ON-SITE SEWAGE DISPOSAL SYSTEM HOWARD COUNTY HEALTH DEPARTMENT BUREAU OF ENVIRONMENTAL HEALTH

05-342317

ADDRESS: 8480 Murphy Road PROPERTY OWNER: Chris Kimmach

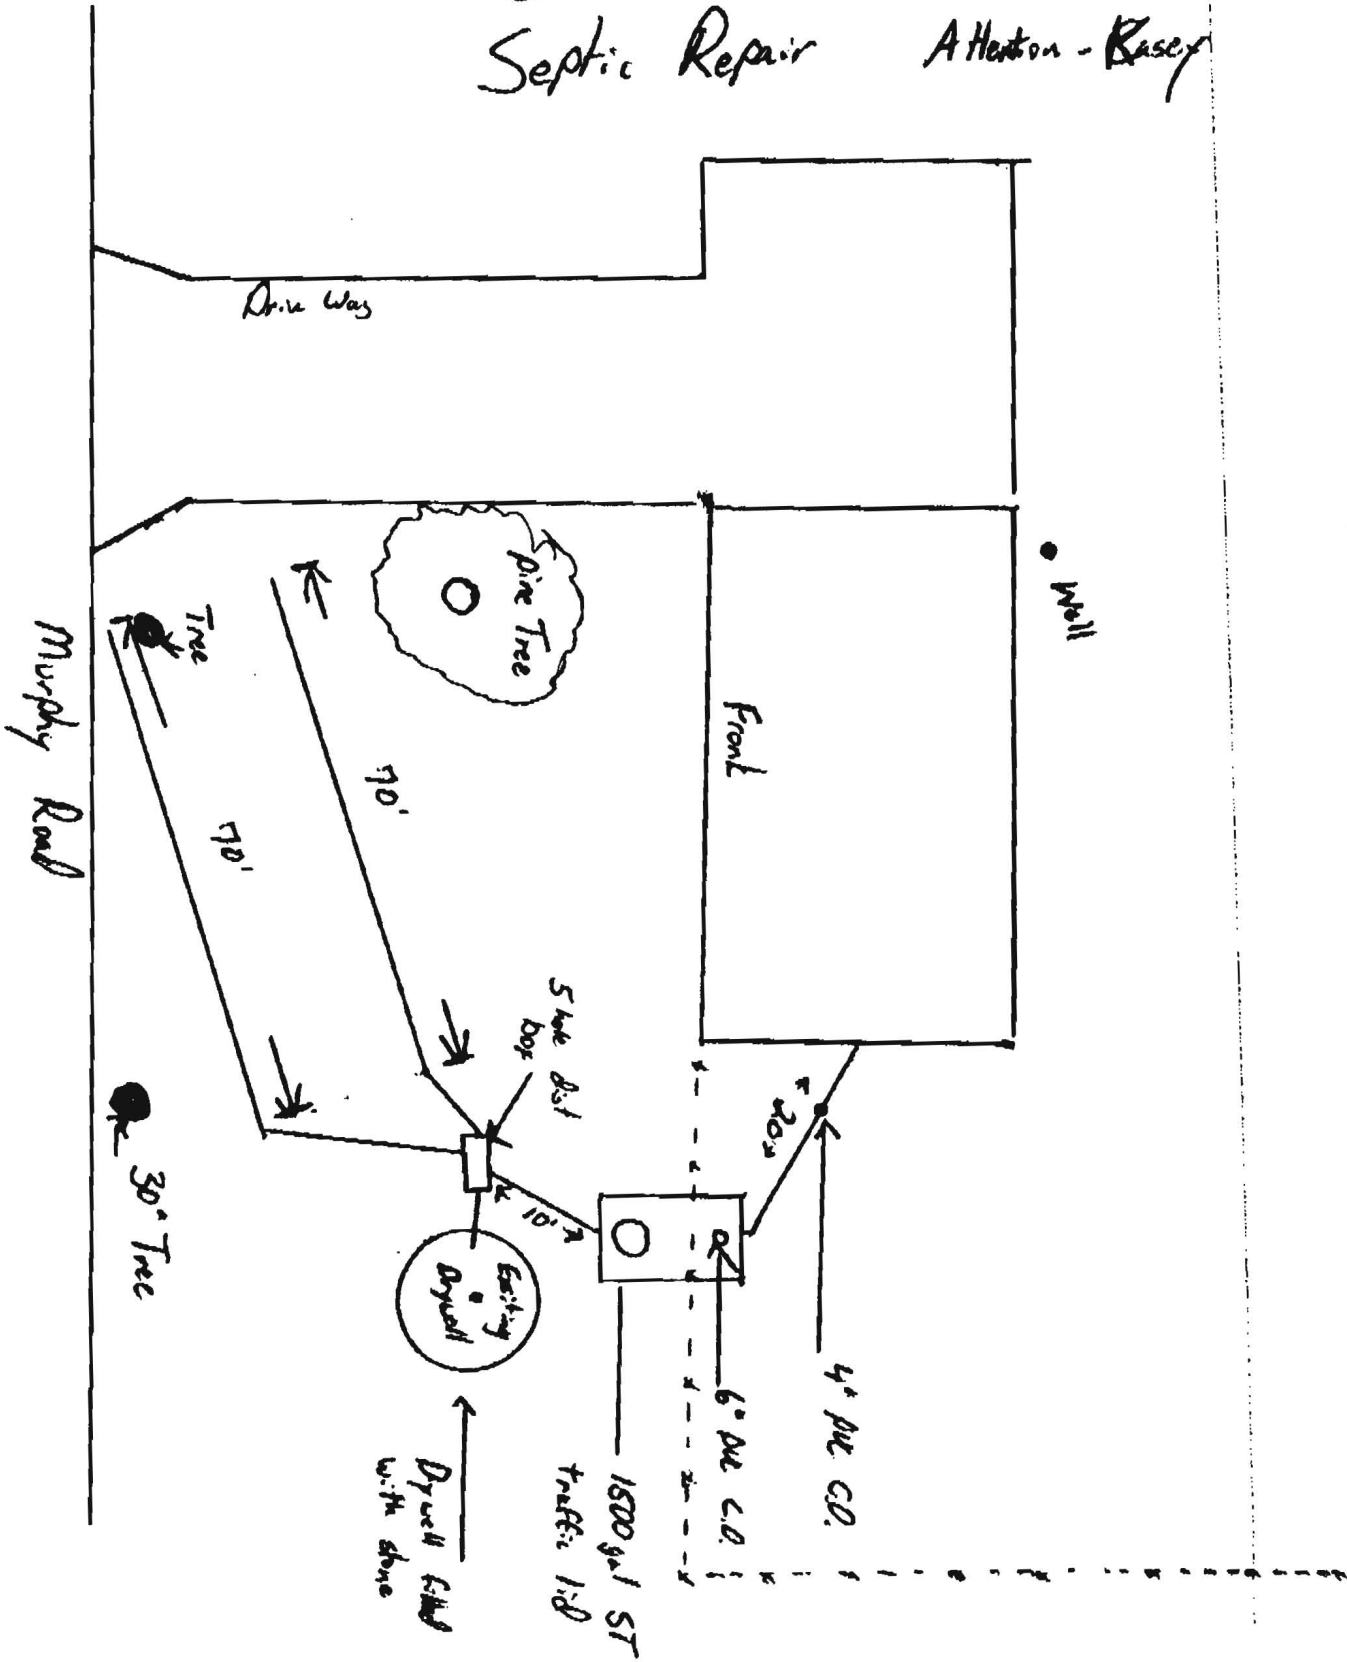
PRE-CONSTRUCTION 3/15/04 SEE SITE inspection form for measurements & soil description. Pond west of property w/ intermittent stream running roughly N to SW. (KW)

INSTALLATION 3/30/04 OK TO cover trench #1 - 70' long. Sandier loam toward driveway. Gravel #2 stone in dry well. SEE ATTACHED DRAWINGS.

SITE INSPECTION SHEET

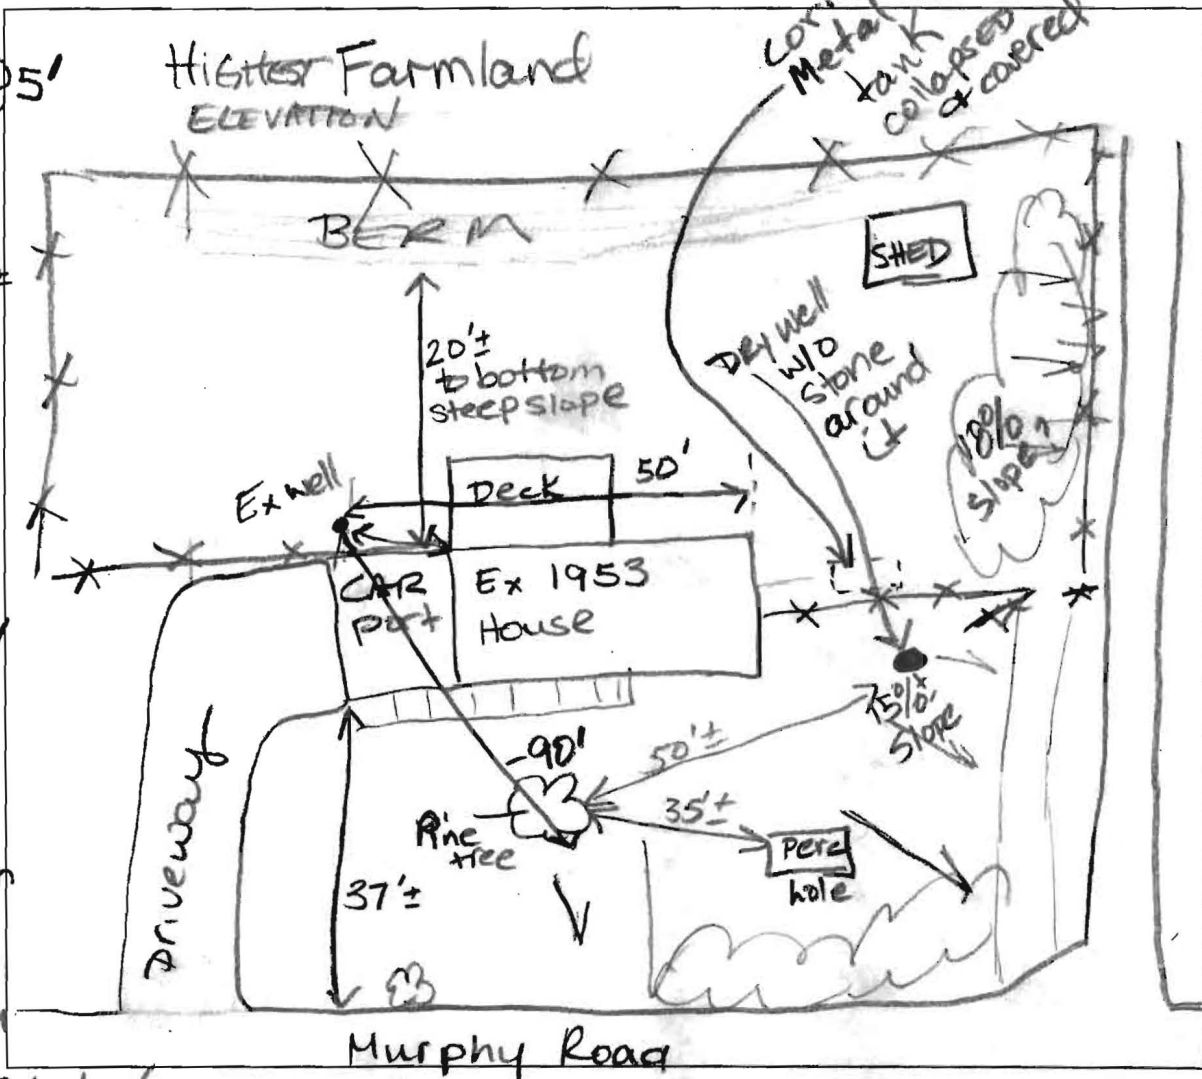
3/15/04
 COMMENTS: Inlet into existing drywell is 6' below grade.
No surrounding well concerns. SPACE ON LOT
Very limited and difficult. Soil texture ideal; however,
structure compact. Rx ~100% or less. Owner had well
 DATE: 3/15/04 INSPECTOR: Karen Roman
tested & gave a copy for the file. WATER CONTENT OK.

Plat of Property known as #8480 Murphy Road, and recorded among the Land Records of Howard County in Liber 1199, Folio 715.

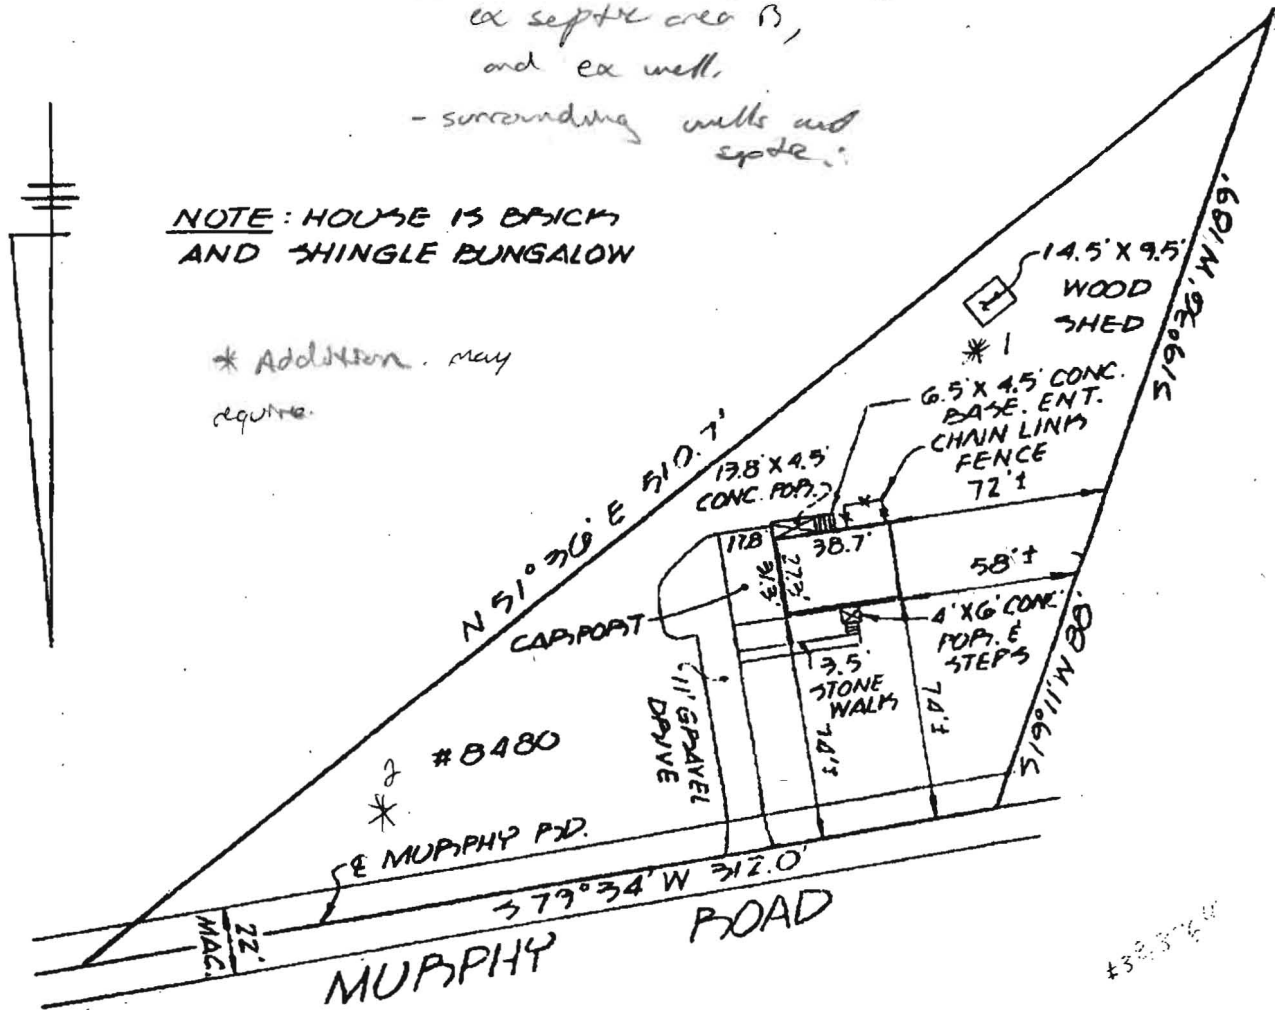
scaled drawings of exact here loc and boundary markers.
- what the addition is going to be
ex septic area B,
and ex well.
- surrounding walls and spots.
